**London Borough of Wandsworth**  
**Local Plan Consultation - Proposed Main Modifications**  
3rd February 2023 to 17th March 2023

**Local Plan Consultation - Proposed Main Modifications**

**Map 18.1 Economic Land**

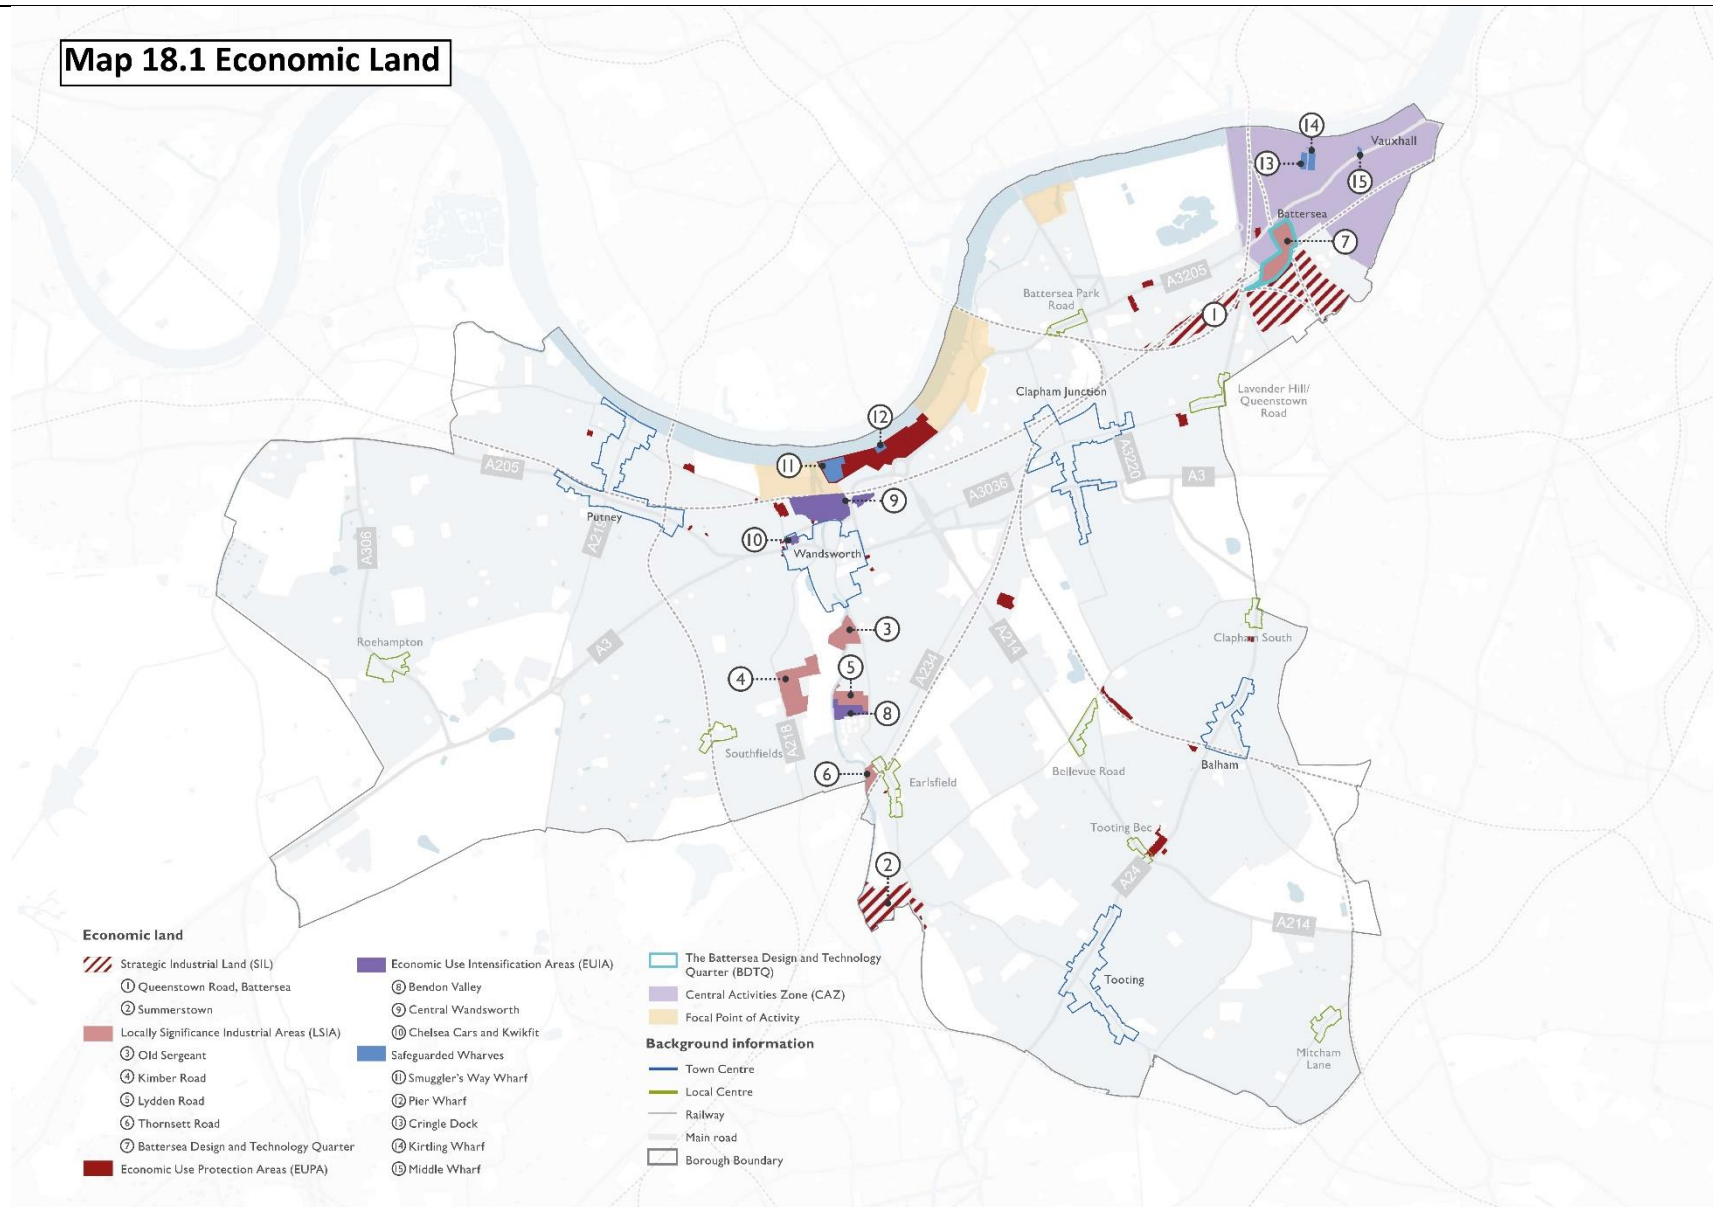
Redesignate the area of the Queenstown Road Battersea SIL which includes Havelock Terrace and Ingate Place north of the railway line to the LSIA to be titled 'Battersea Design and Technology Quarter LSIA'.	To correctly reflect the area of significance for this designation.	In response to the GLA to ensure general conformity with the London Plan policies E4 and E7.

**Map 19.1 Designated Centres and Frontages**

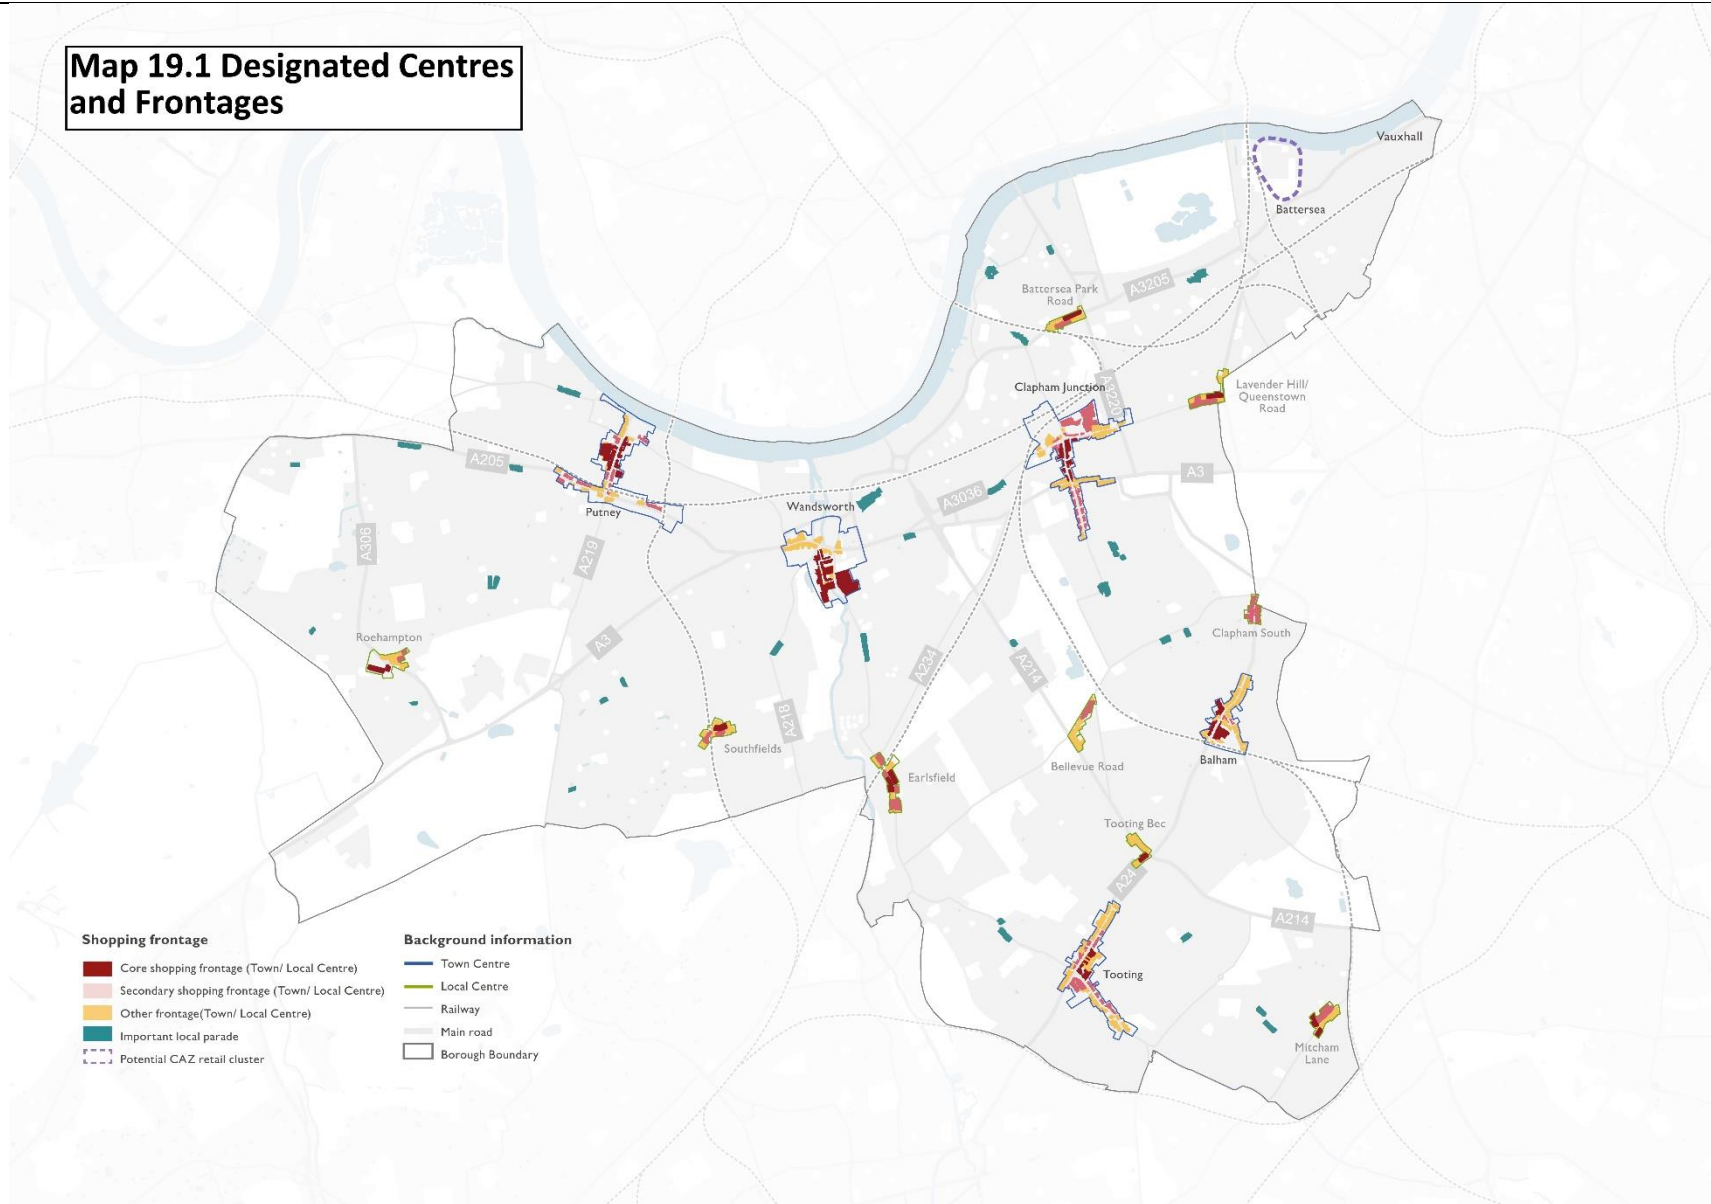
Main Modification Number	Section of the Plan	Proposed Main Modification	Justification	Reason for change
		<p><i>took forward the recommendations of the</i> Implementation Report - Safeguarding Wharves Review 2018-2019 <del>recommended</del> that this status is retained for all of Wandsworth's wharves, and <del>that</del> all planning applications affecting safeguarded wharves must be referred to the Mayor.'</p>		
MM227	Map 19.1 Designated Centres and Frontages	Redesignate '360-374 Garratt Lane' as Secondary Frontage, rather than Other Frontage.	Reclassified to reflect their more central location.	As a result of Reg 19 Repls.
		Redesignate '376-408 Garratt Lane' as Core Frontage, rather than Other Frontage.	Reclassified to reflect their more central location.	As a result of Reg 19 Repls.
